**CULTURAL RESOURCES OFFICE
 PRESERVATION BOARD
 REGULAR MEETING
 MONDAY – JULY 25, 2016 — 4:00 P.M.
 1520 MARKET ST. #2000
 ST. LOUIS, MO. 63103
www.stlouis-mo.gov/cultural-resources**

DATE: July 25, 2016
ADDRESS: 4161 Castleman Avenue
ITEM: Preliminary Review: Construct a new front porch and front door replacement
JURISDICTION: Shaw Neighborhood Local Historic District — Ward 8
STAFF: Bob Bettis, Preservation Planner, Cultural Resources Office

DATE: July 25, 2016
ADDRESS: 5780 McPherson Avenue
ITEM: Preliminary Review: Construction one single-family house
JURISDICTION: Skinker-DeBaliviere Certified Local Historic District — Ward 26
STAFF: Bob Bettis, Cultural Resources Office

DATE: July 25, 2016
ADDRESS: 3310, 3314 and 3318-20 Lemp Avenue
ITEM: Preliminary Review: construction of two single-family houses and one two-family building
JURISDICTION: Benton Park Local Historic District — Ward 9
STAFF: Jan Cameron, Cultural Resources Office

PROPOSED NEW PORCH AND ALTERED ENTRY

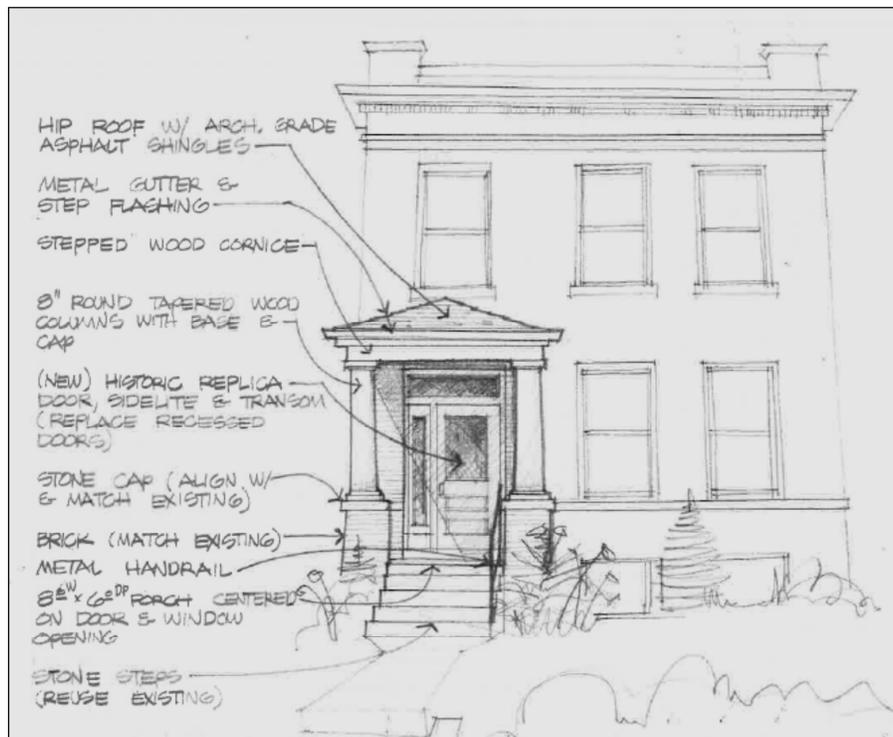
Does not comply. The house, constructed in 1906, was constructed with a recessed entry in place of a porch. Although the proposed porch is of an appropriate design, the introduction the new feature is counter to the Standards which state that original details should be retained in their original configuration.

The owners also are proposing to enclose the recessed entry and to install a single door with sidelight in place of paired doors. This is also not compliant with the Standards as gives the entry an appearance it never had historically.

- The Cultural Resources Office and the Preservation Board have never supported the conversion of an existing paired entry to a single entry.

That the Preservation Board deny the Preliminary Application as the proposed porch and entry reconfiguration do not comply with the Shaw Historic District Standards.

FRONT ELEVATION

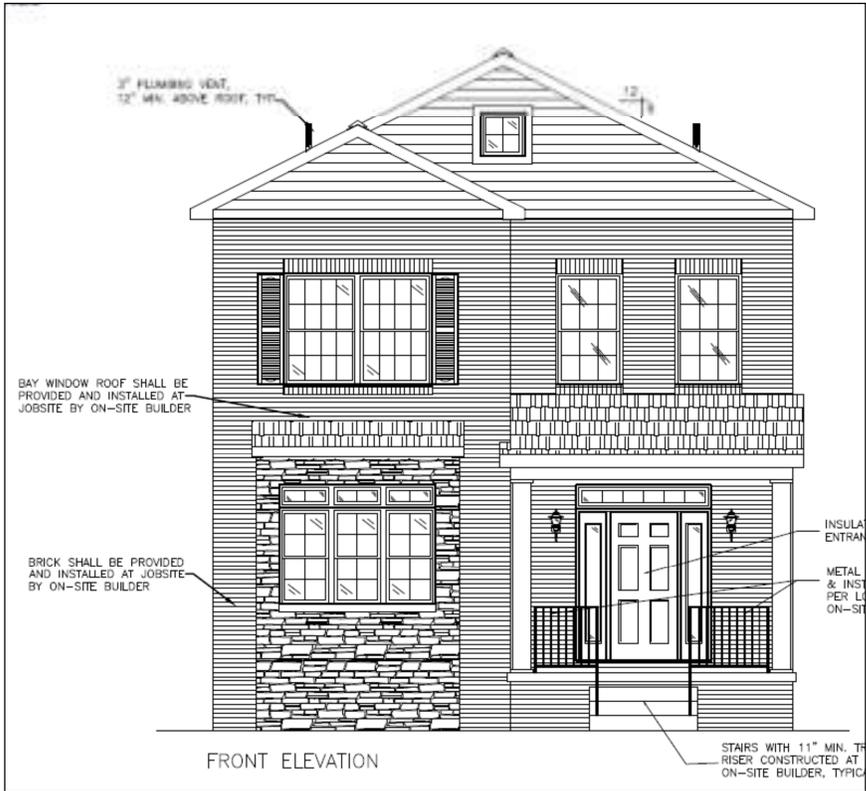
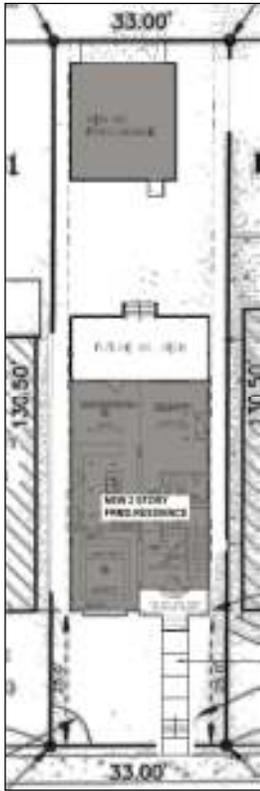
Complies. Proposed building floor heights, window proportions, scale and materials are compatible with the adjacent buildings.

Complies. There are a number of different roof types on the block. The selected gabled roof is compatible with the surrounding structures.

Complies. The proposed fence will be six feet in height and made of wood.

RECOMMENDATION:
That the Preservation Board grant preliminary approval to this proposal with the condition that final design details and materials be reviewed and approved by the Cultural Resources.

STREETSCAPE

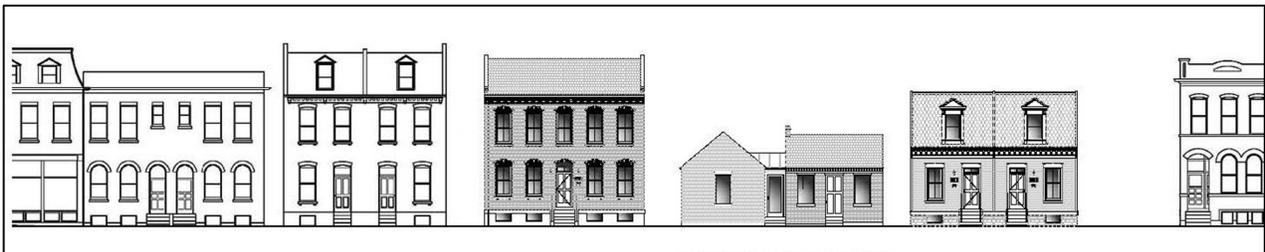
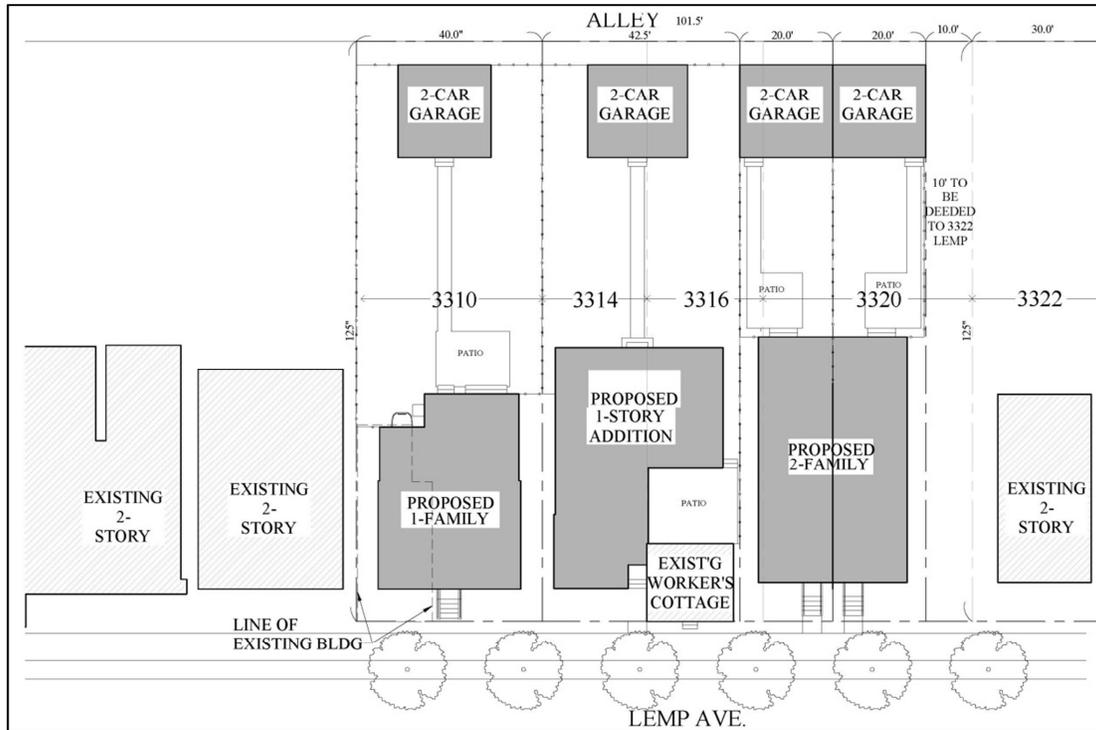
No Model Examples have been submitted, but the design of 3310 and 3318-20 follow historic precedents in the neighborhood. The design of the addition at 3316 does not, but is consistent in scale and materials to historic examples.

Mostly complies. 3310 Lemp and 3318-20 will brick front facades. The addition to 3316 Lemp, however, will have a proposed panel system. This material has been approved by the Preservation Board for infill buildings in Benton Park of contemporary design and is considered compatible with historic material if in an appropriate color.

STAFF RECOMMENDATION:
That the Preservation Board grant preliminary approval for the new construction, with the stipulation that final drawings, materials and colors be reviewed and approved by the Cultural Resources Office.

NEW PORCH AND DECK

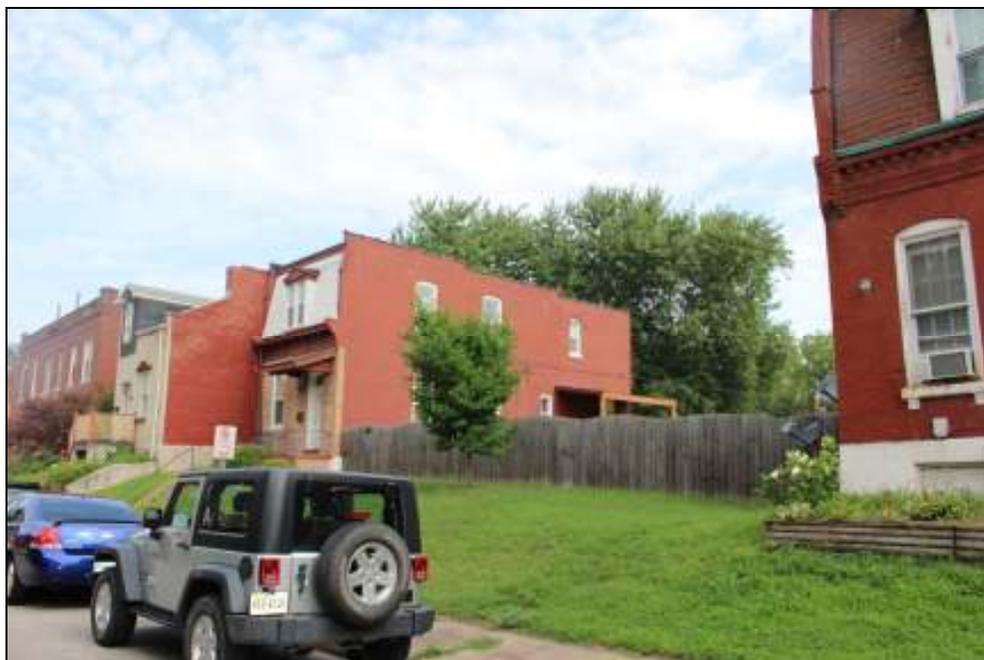
Although there was a porch in the same location, the handrails and construction are not based on a Model Example. In addition, the deck is not allowed as it is not at the rear of the building.

The handrail used on the porch and deck do not conform to the historic district standards, as it is of a contemporary design. The porch and deck are stained, but it is not an opaque stain.

STAFF RECOMMENDATION:
That the Preservation Board uphold the Director's Denial as the deck does not meet the Benton Park Historic District standards.
